SUNDRY NOTICES AND REPORTS ON WELLS (DO NOT USE THIS FORM FOR PROPOSALS TO DRILL OR TO DEEPEN OR PLUG BACK TO A DIFFERENT RESERVOIR. USE "APPLICATION FOR PERMIT" (FORM C-101) FOR SUCH PROPOSALS.)		7. Lease Name or Unit Agreement Name RIO BRAVO

NOBLE ENERGY, INC. PROPOSES TO PLUG AND ABANDON THIS WELL PER THE ATTACHED PROCEDURE AND DOWNHOLE SCHEMATIC.

PLUG AND ABANDONMENT PROCEDURE

Rio Bravo #1

Rio Bravo #1
 Proposed P&A
 Basin Fruitland Coal
 890' FNL, 1820' FEL
 Sec. 27, T31N-R13W, San Juan County, NM

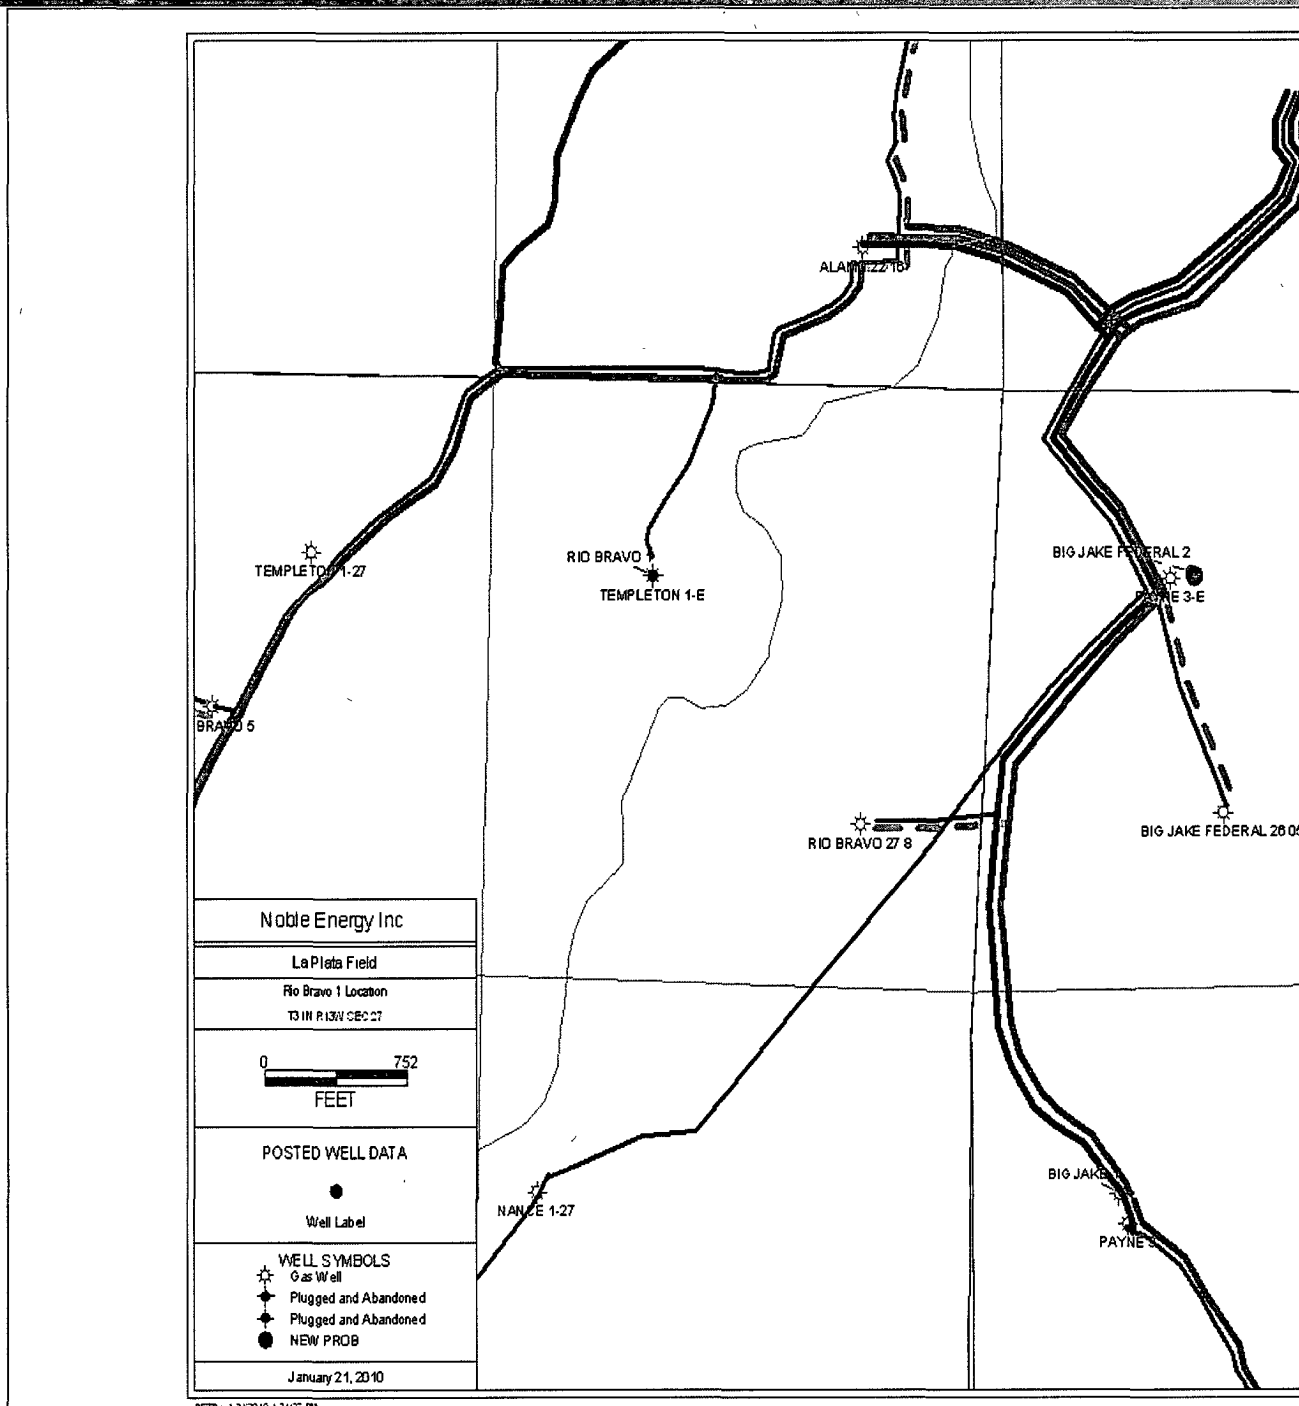
4. **Plug #1 (Pictured Cliff top and Fruitland perforations and top: 1800' - 1008')**: TIH and tag the CIPB at 1800' or as deep as possible. Pump 60 bbls water down the tubing to attempt to circulate the well. Mix 75 sxs Class B cement and spot a balanced plug inside the casing to isolate the PC and Fruitland perforations and tops. TOH with tubing and WOC. TIH and tag cement; TOC should be above 1280'. Circulate the well clean with water. Pressure test casing to 500#. *If the casing does not test, then spot or tag subsequent plugs as appropriate. TOH and LD the tubing.*
add Plug #2 Fruitland/Nacimiento 769' - Plug from 719' to 819'

APPROVED BY: *Fally G. Roda* TITLE **Deputy Oil & Gas Inspector,**
District #3 DATE **2/23/10**
Conditions of Approval (if any): **See changes**
